ONE SYDNEY HARBOUR

STAGE 1B - Building R4B

SECTION 4.55

ARCHITECTURAL DRAWINGS

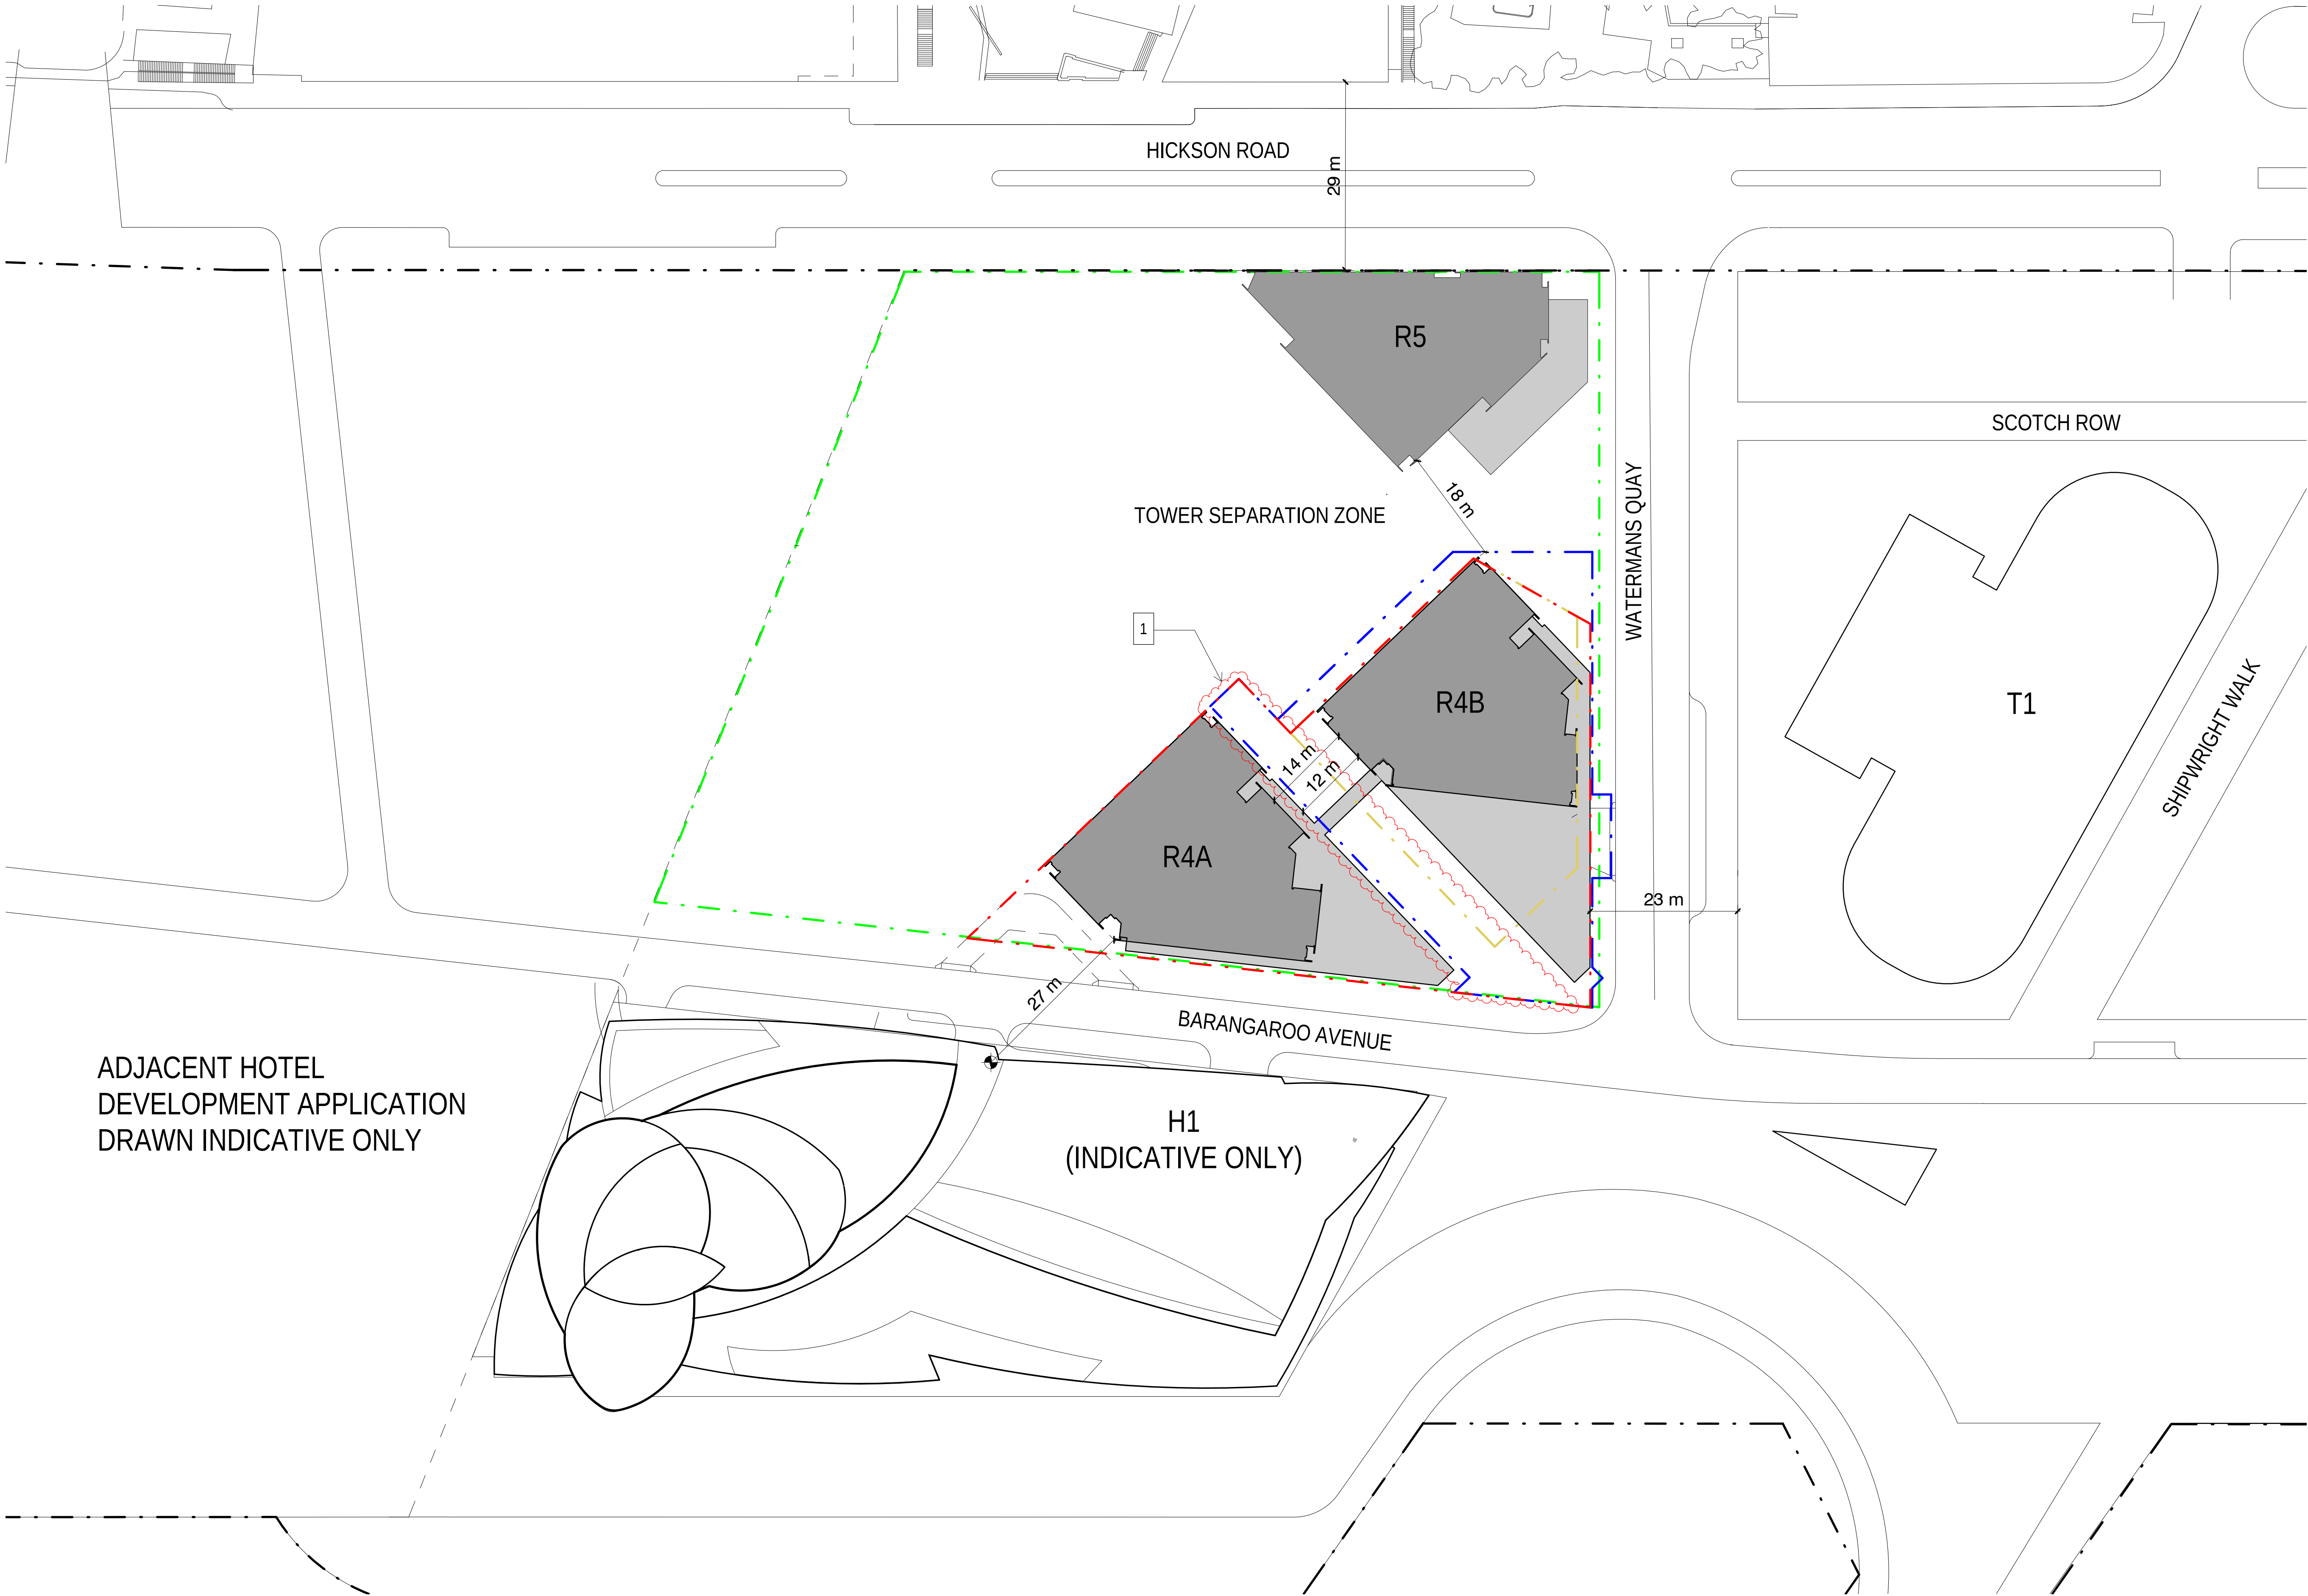
- DEVELOPMENT APPLICATION BOUNDARY CHANGED.
- VESTIBULE AMENDED.
- DOUBLE DOOR SECONDARY LOBBY EXIT ADDED.

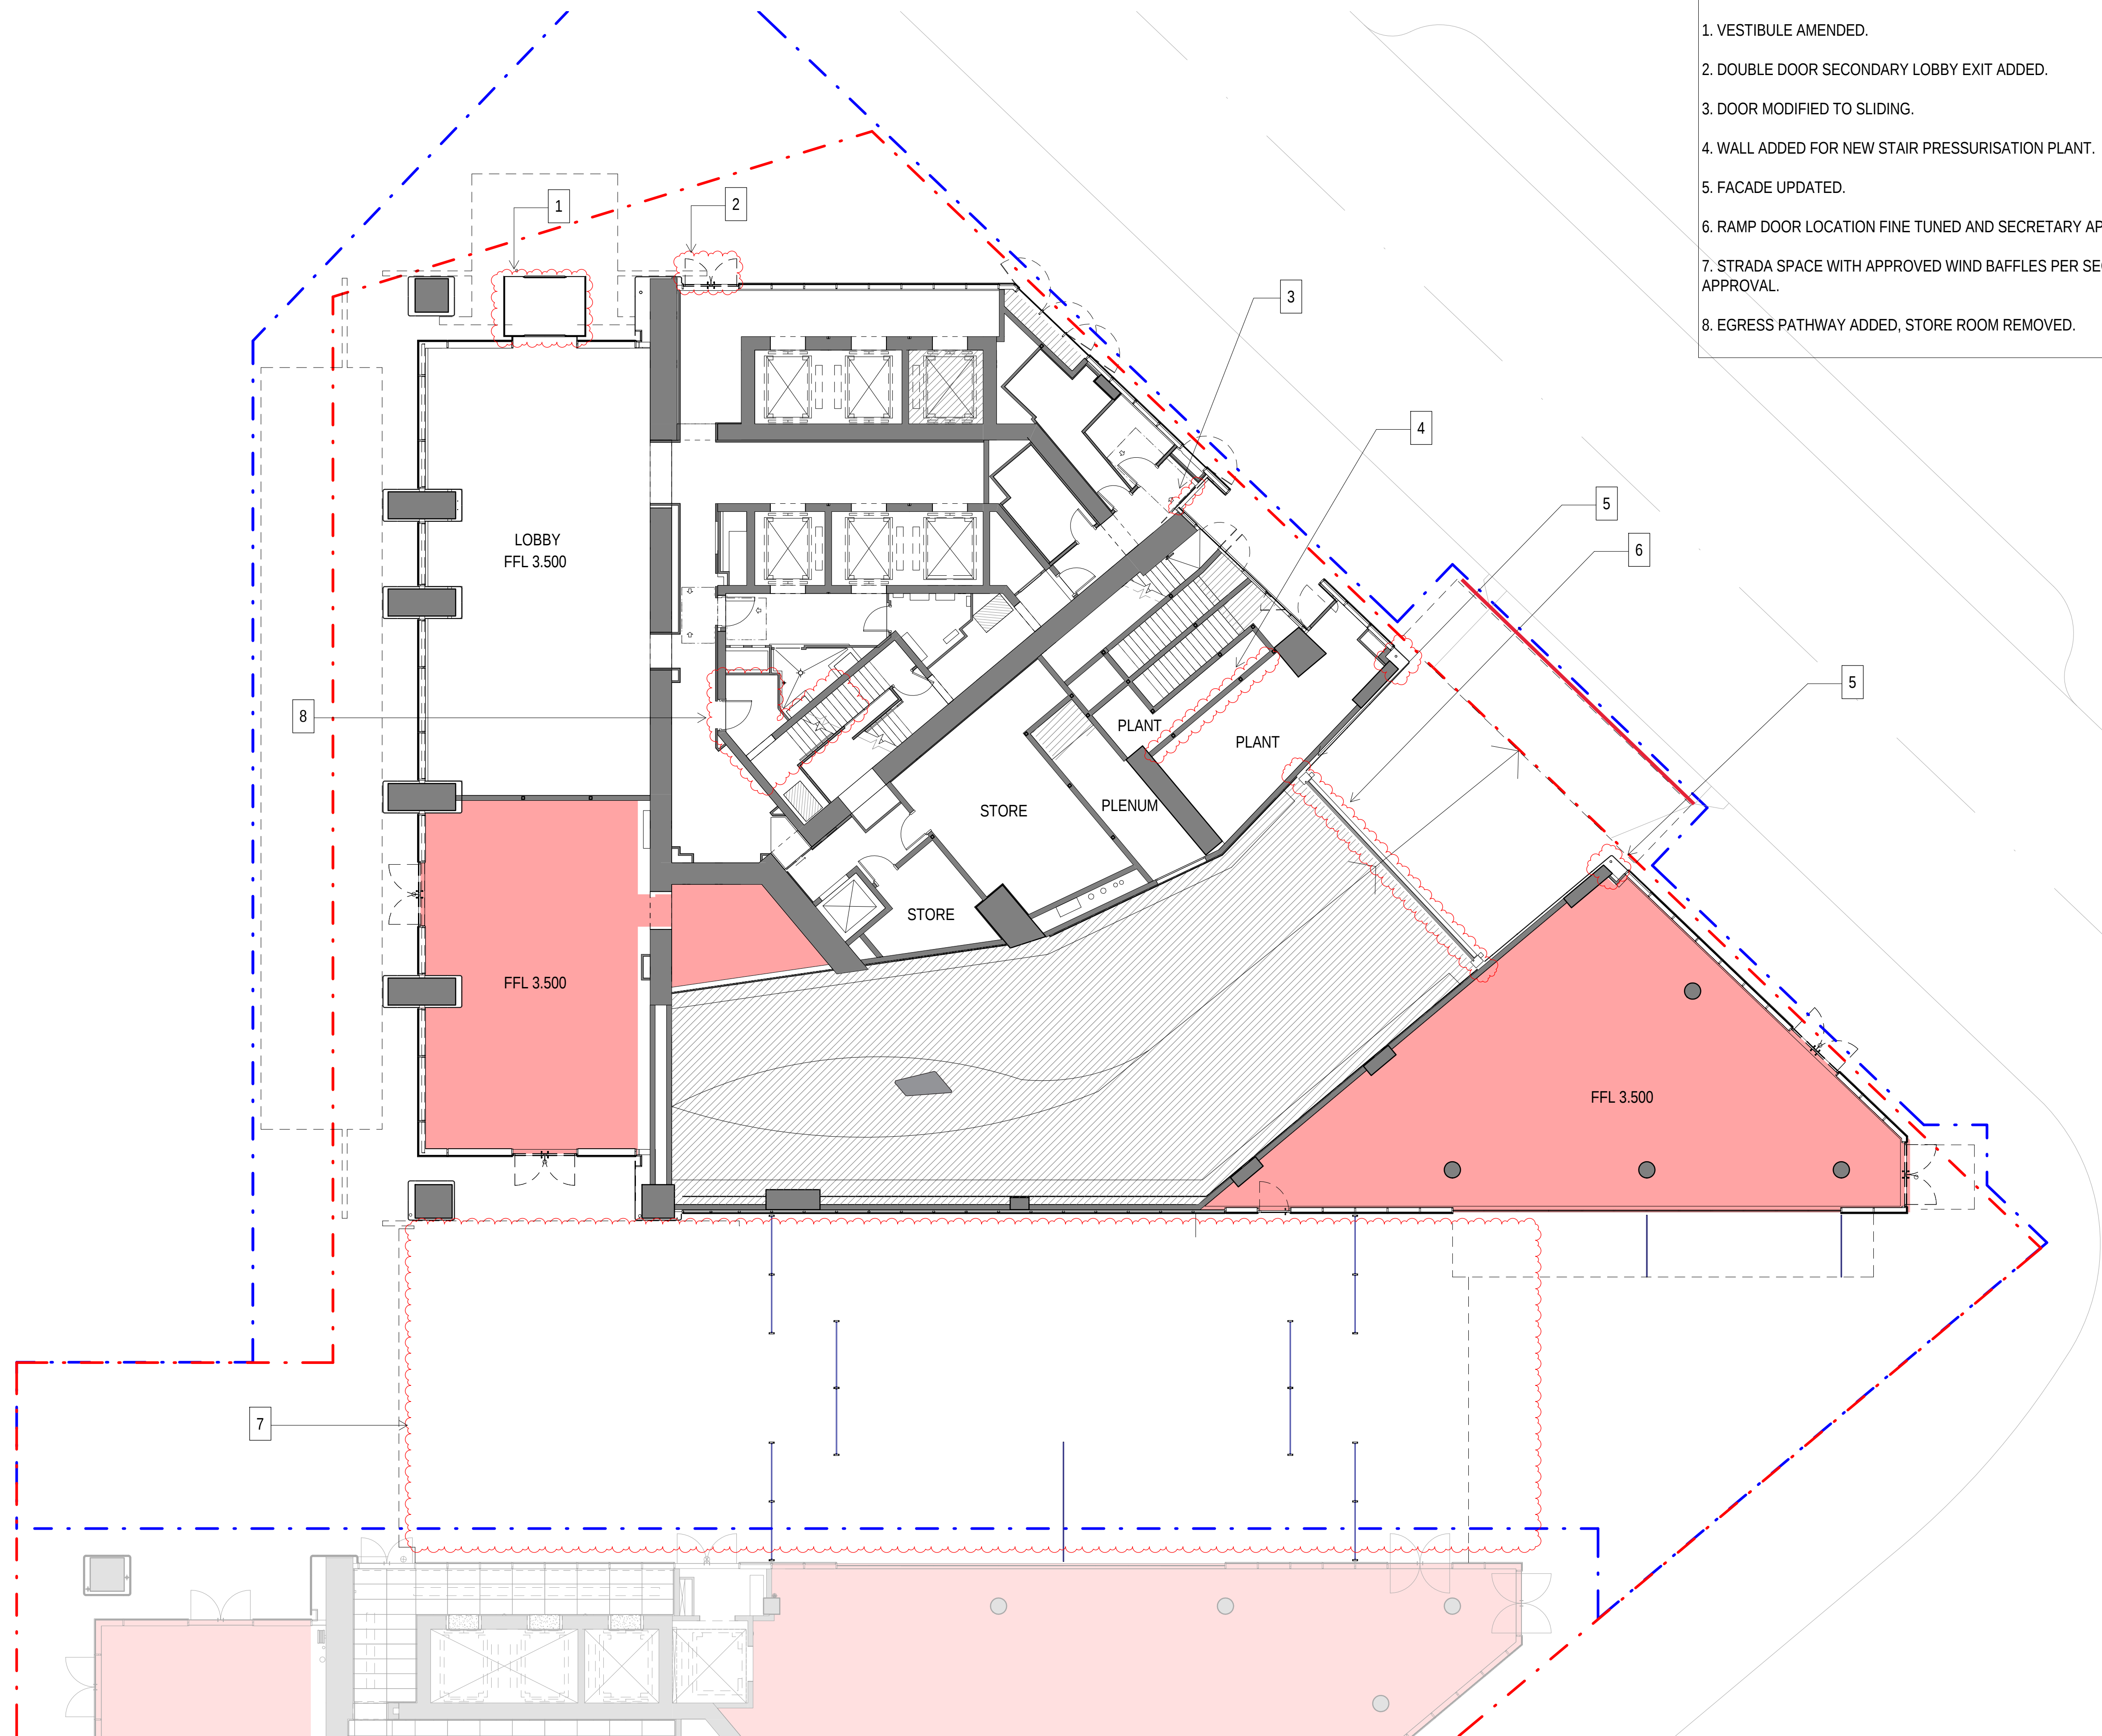
1. DEVELOPMENT APPLICATION BOUNDARY CHANGED.

LEVEL	RL
Ground Floor	3.500

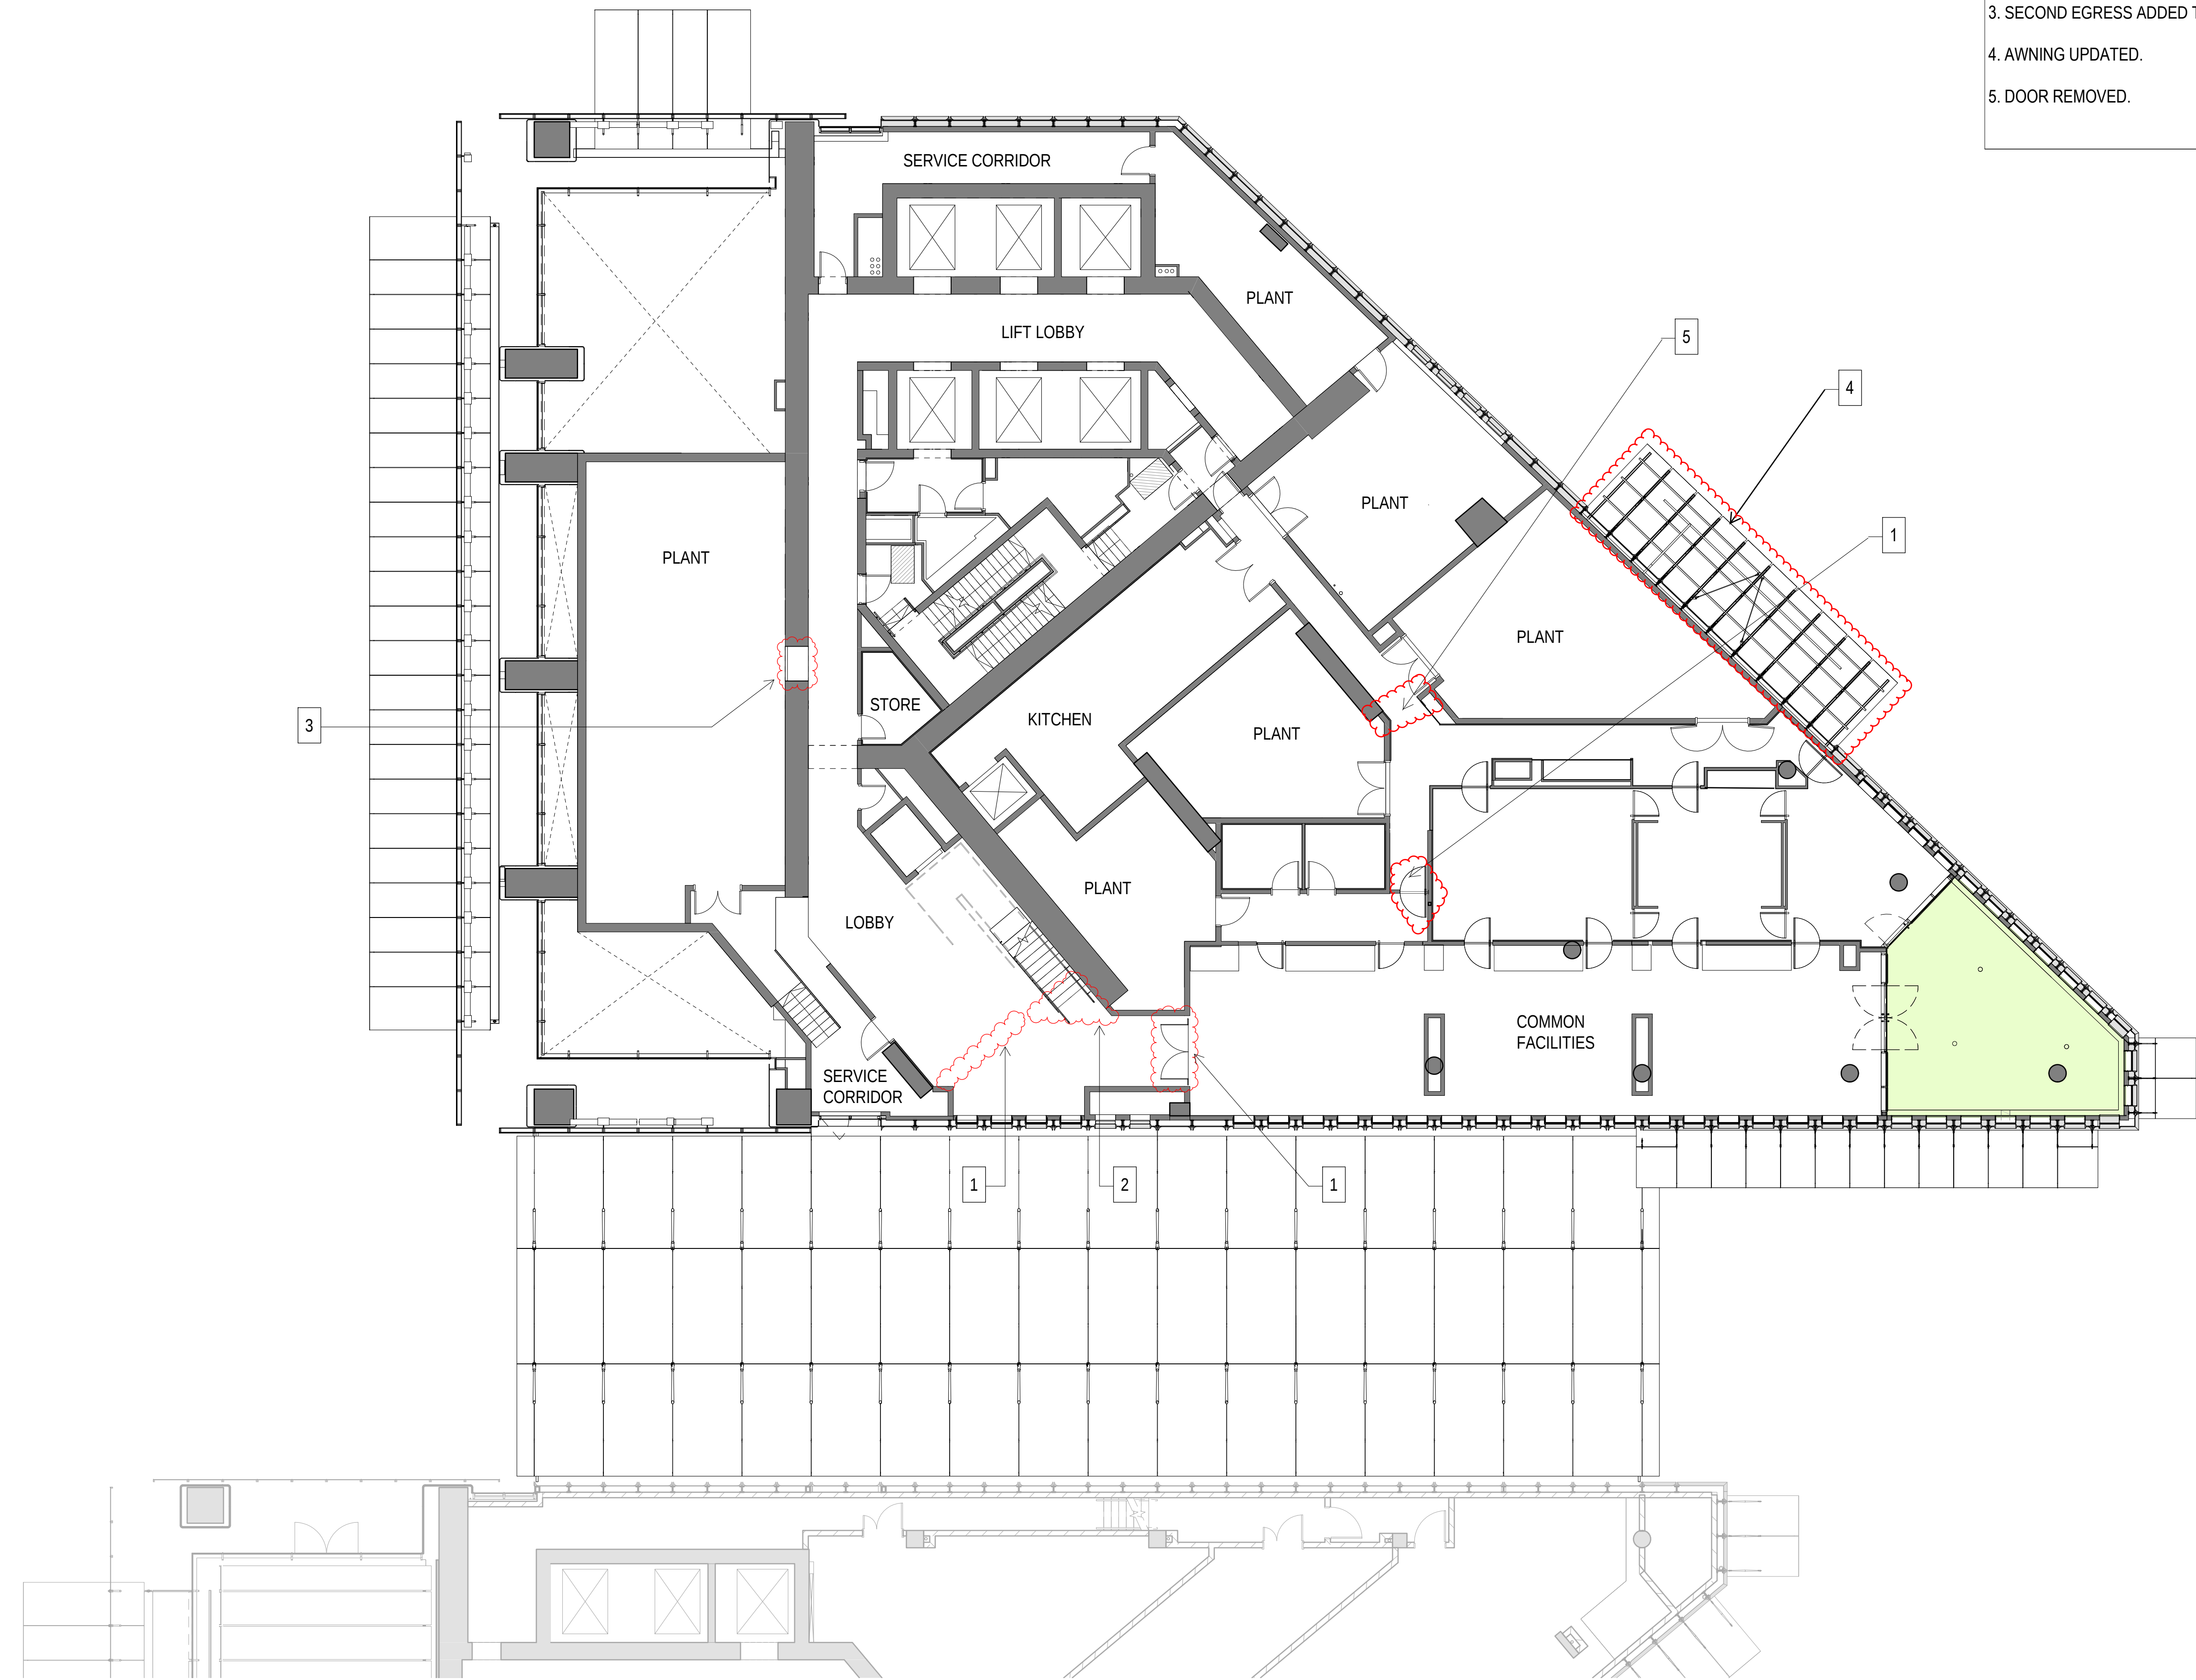
- MODIFICATION:**
1. VESTIBULE AMENDED.
 2. DOUBLE DOOR SECONDARY LOBBY EXIT ADDED.
 3. DOOR MODIFIED TO SLIDING.
 4. WALL ADDED FOR NEW STAIR PRESSURISATION PLANT.
 5. FACADE UPDATED.
 6. RAMP DOOR LOCATION FINE TUNED AND SECRETARY APPROVAL.
 7. STRADA SPACE WITH APPROVED WIND BAFFLES PER SECRETARY APPROVAL.
 8. EGRESS PATHWAY ADDED, STORE ROOM REMOVED.
